Addendum # 4
Bid Opportunity: 26-7860-RFT
Galt Collegiate Institute
Boiler Replacement and H&V Upgrades - Phase 2
Closing Date: Monday, April 20, 2026 2:00 PM

Project Name: Galt Collegiate Institute Boiler Replacement and H&V upgrades – phase 2

1 ENLARGED FIRST LEVEL DEMOLITION FLOOR PLAN
 ASK-001
 0 1 2.5 5 10 m
 1:100

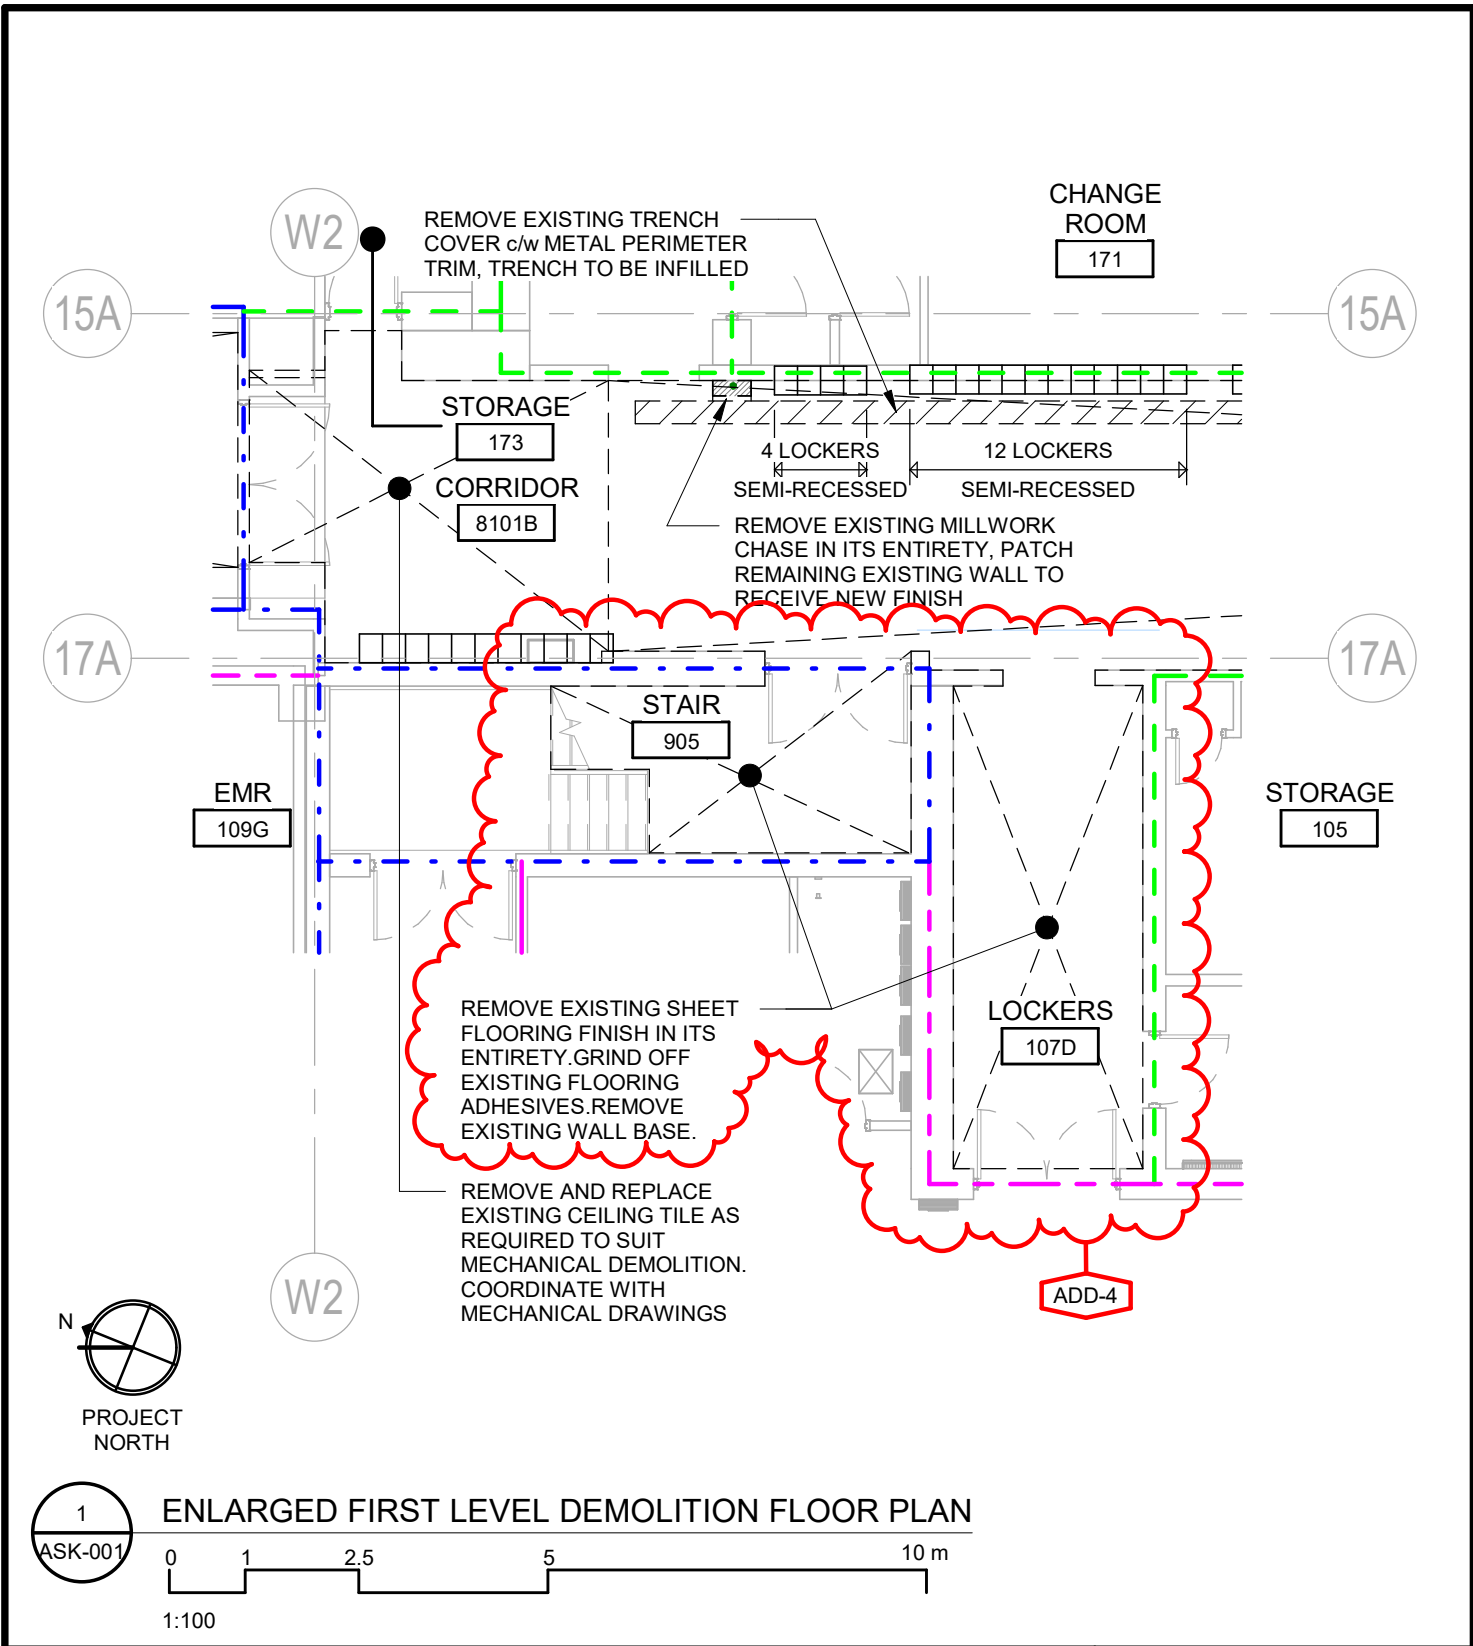
**.1 ENLARGED FIRST LEVEL DEMOLITION FLOOR PLAN
2/A2.03: REMOVE FLOORING AND BASE INCLUDING ALL
ADHESIVE, AT LOWER LANDING IN STAIR 905, LOCKERS
107D. REFER TO DRAWING ASK-001, ATTACHED.**

ASK-002

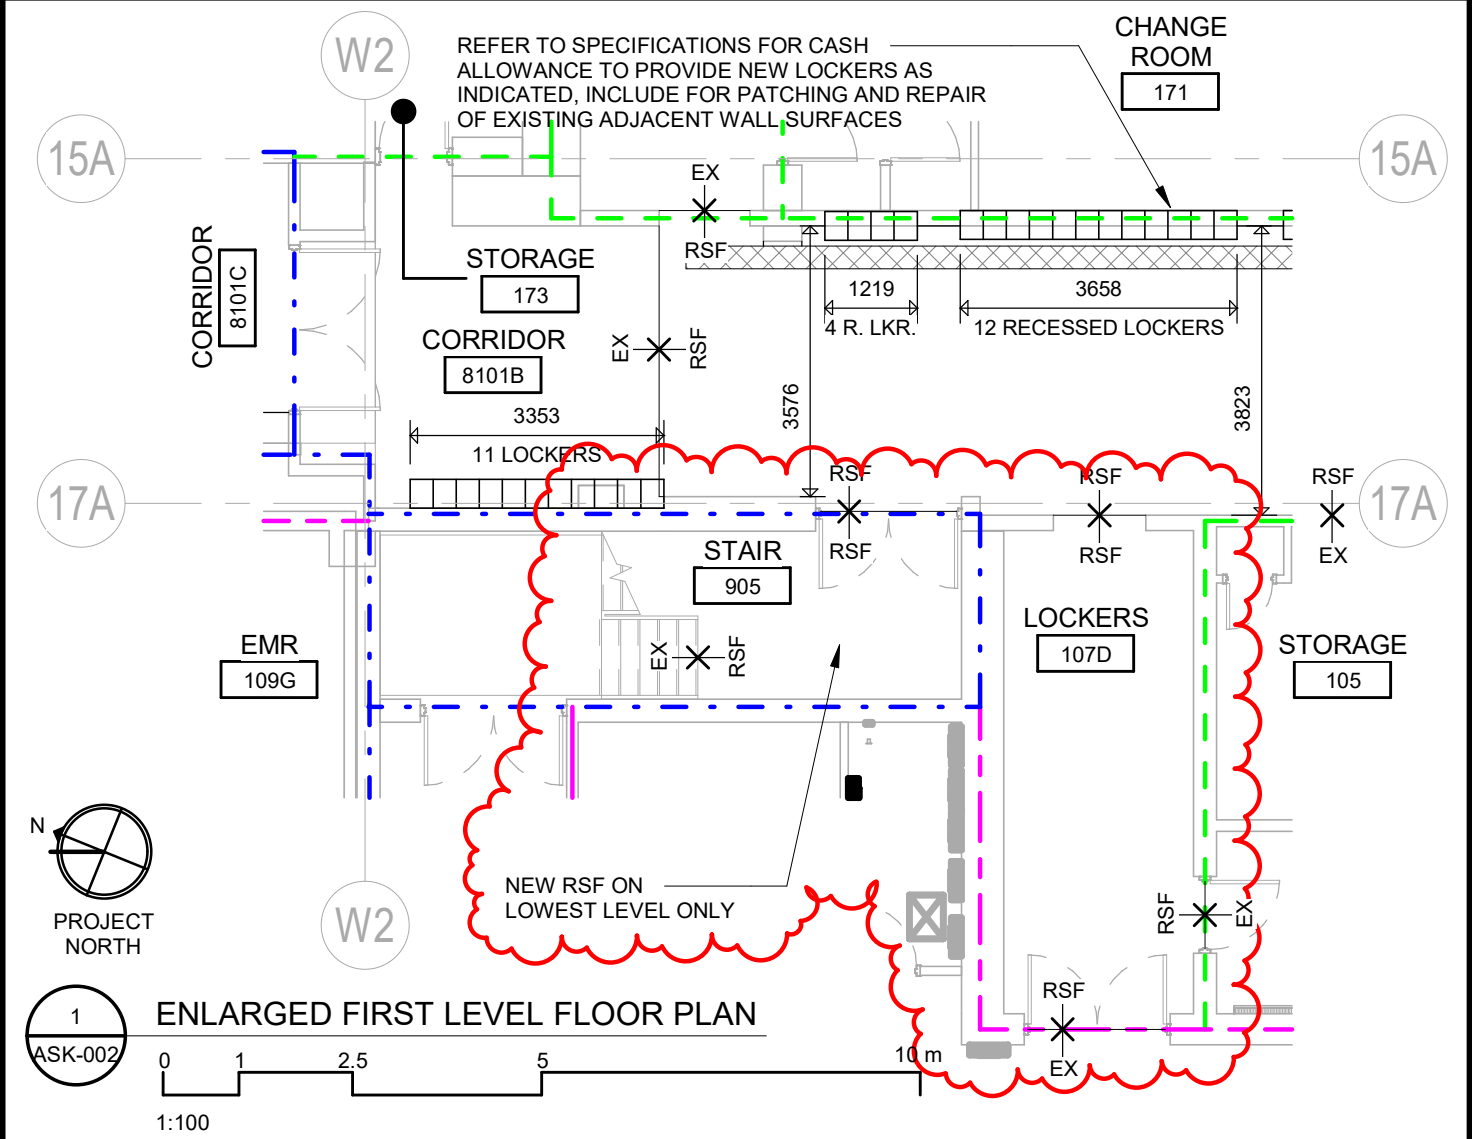
**.1 ENLARGED FIRST LEVEL FLOOR PLAN 2/A3.03:
PROVIDE NEW RESILIENT SHEET FLOORING AND
RUBBER BASE AT LOWER LANDING IN STAIR 905, AND
IN LOCKERS 107D. REFER TO DRAWING ASK-002,
ATTACHED.**

S2.02

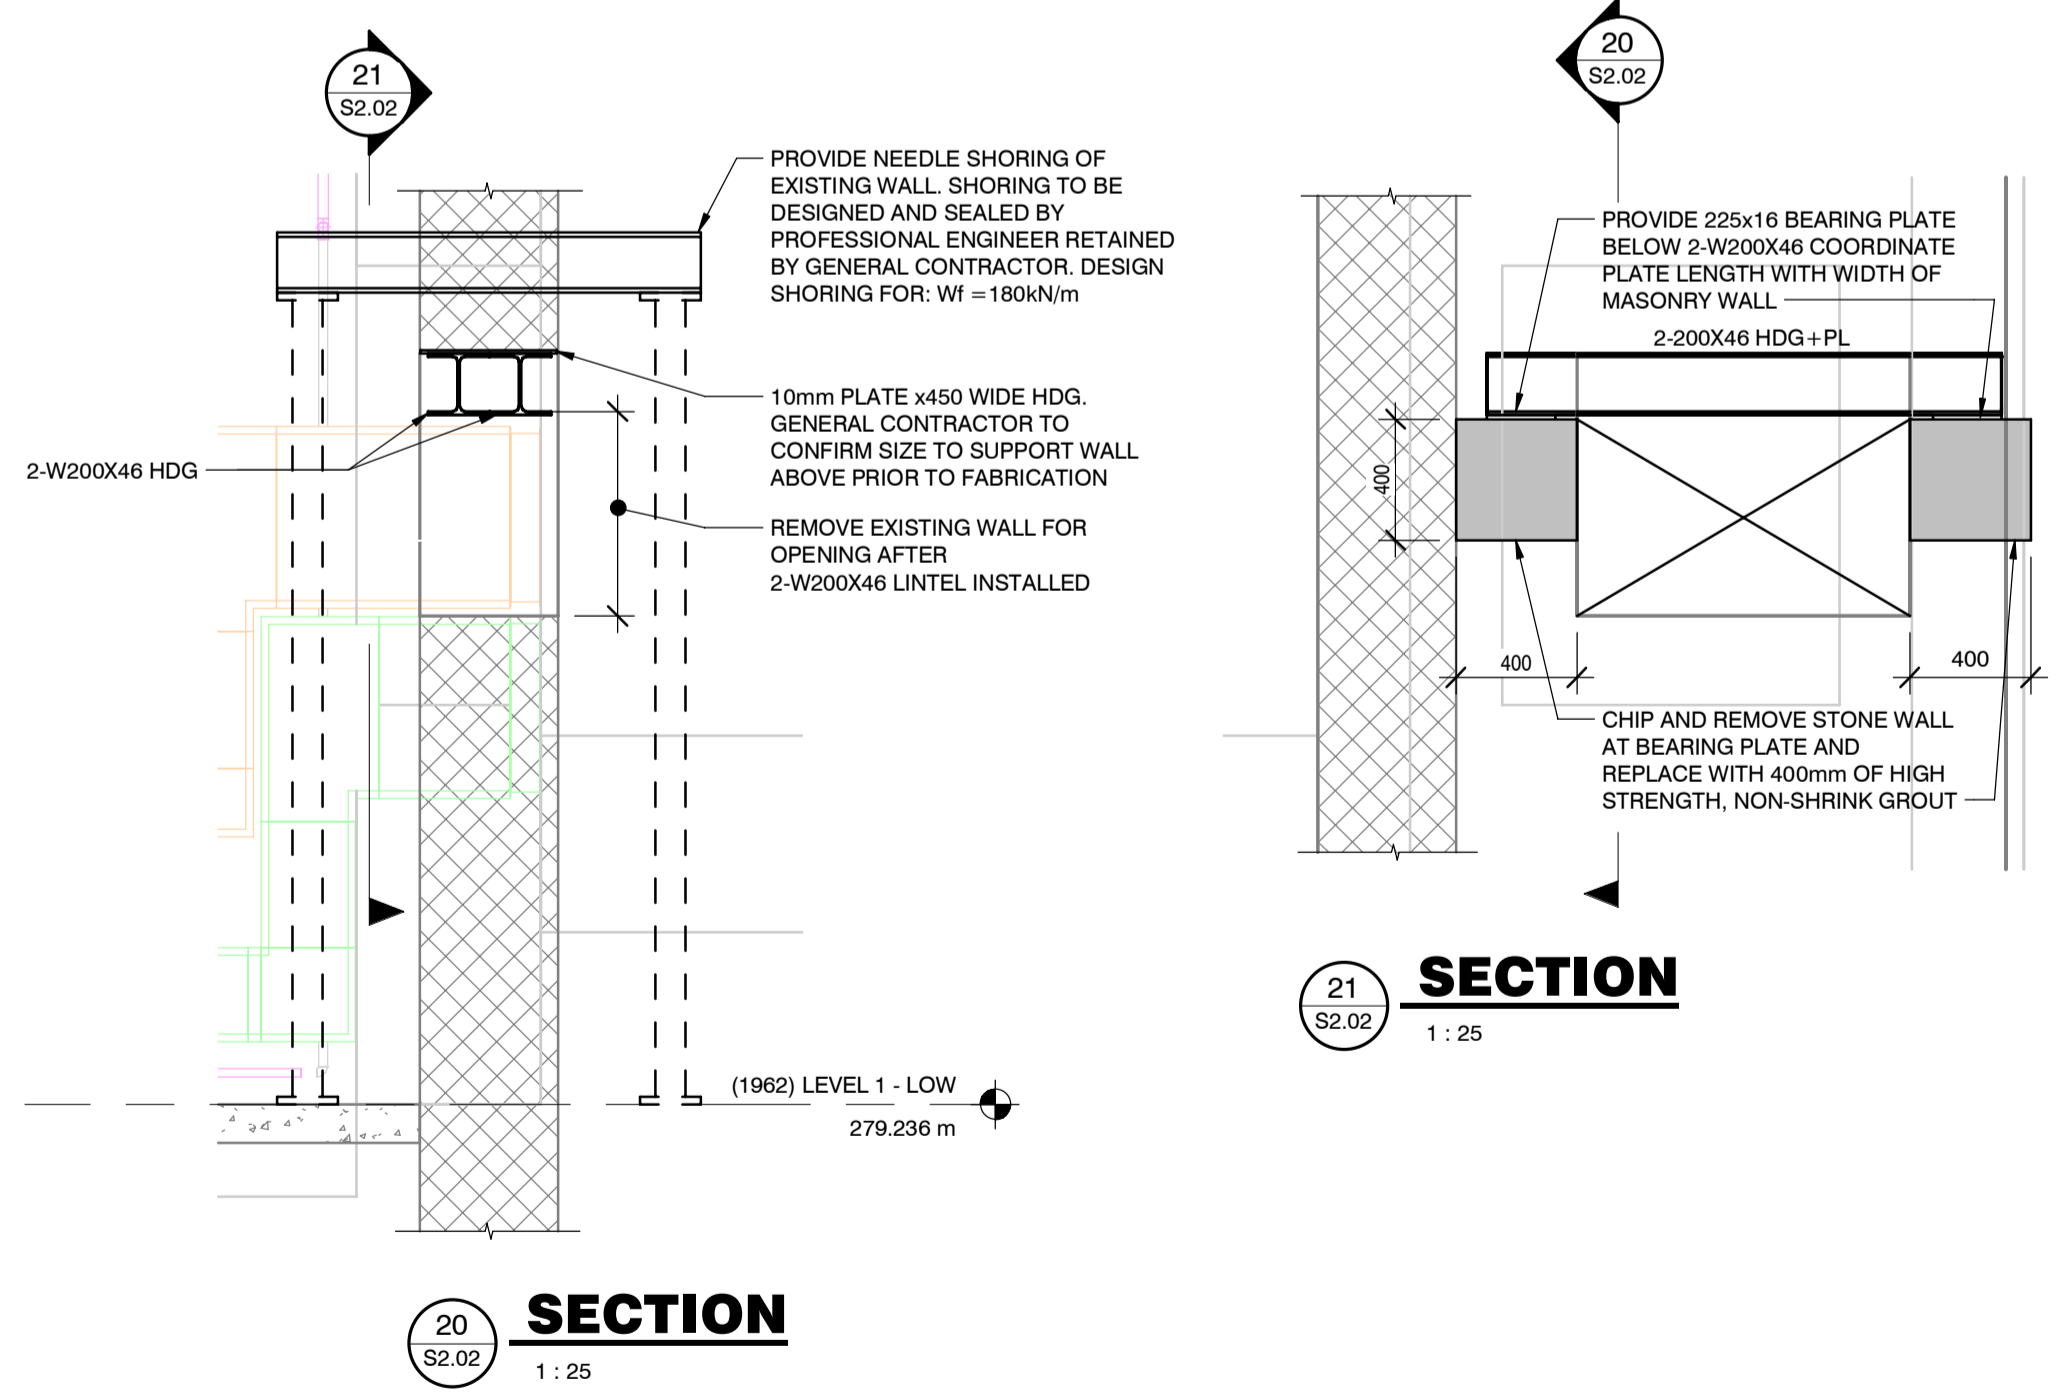
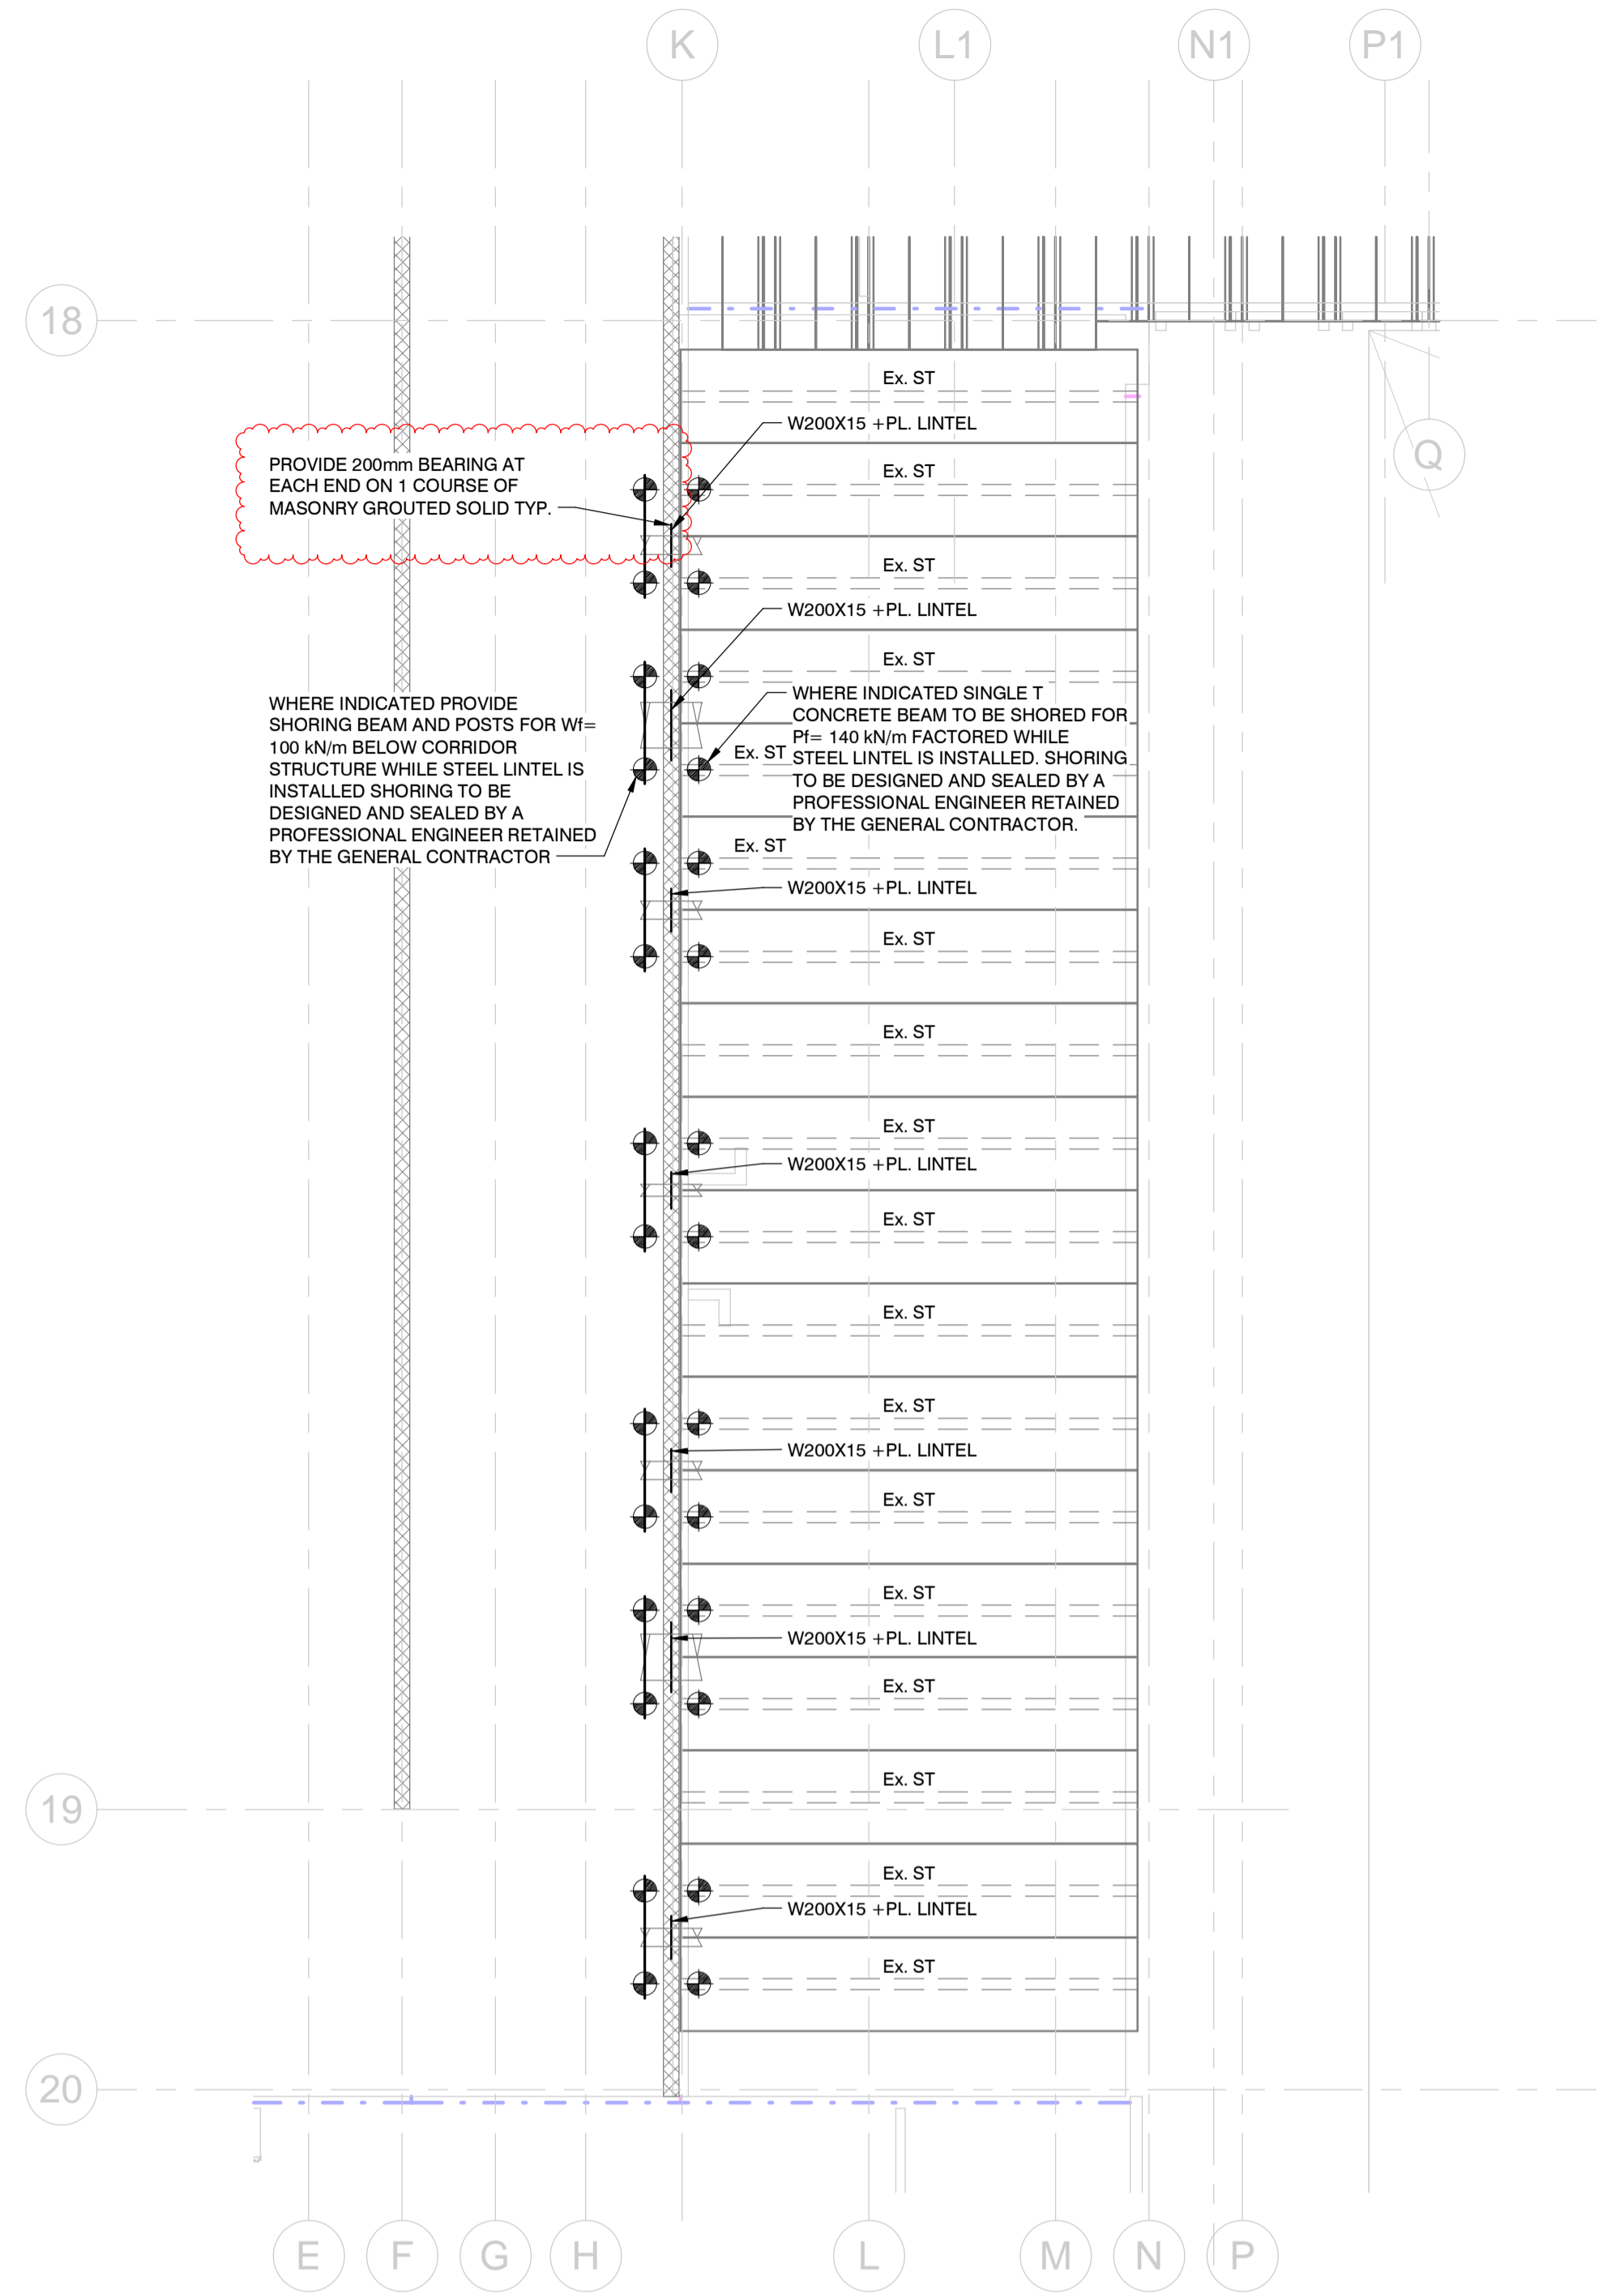
Please provide the baseplate size and detail for the W200 x15 lintels shown on the level2 framing plan drawing S2.02

-
- S2.02, Added clarification for W200x15 lintels bearing conditions.

For the W200x15 lintel no bearing plate is required. Provide 1 course of masonry grouted solid below bearing. Structural addendum to be issued.
